Mustang II Service Bulletin

SUBJECT: T-18 Canopy Installation

Top View T-18 Roll Bar Attachment

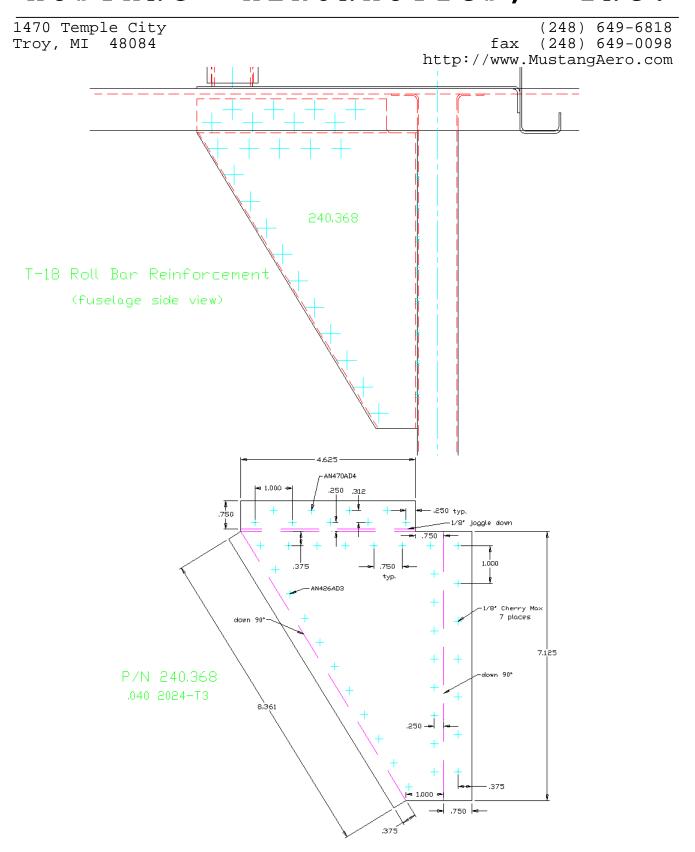
When using the T-18 style canopy on the Mustang II, the roll bar assembly needs to be moved aft for a proper fit of the windscreen. The T-18 roll bar is moved 6 inches aft as shown below. The roll bar attach bracket (240-203) is stretched and a reinforcing gusset (240-368) installed between it and the sta. 73.75 vertical bulkheads. The roll bar brace (240-210) is also lengthened from 17 inches to 22.125 inches.
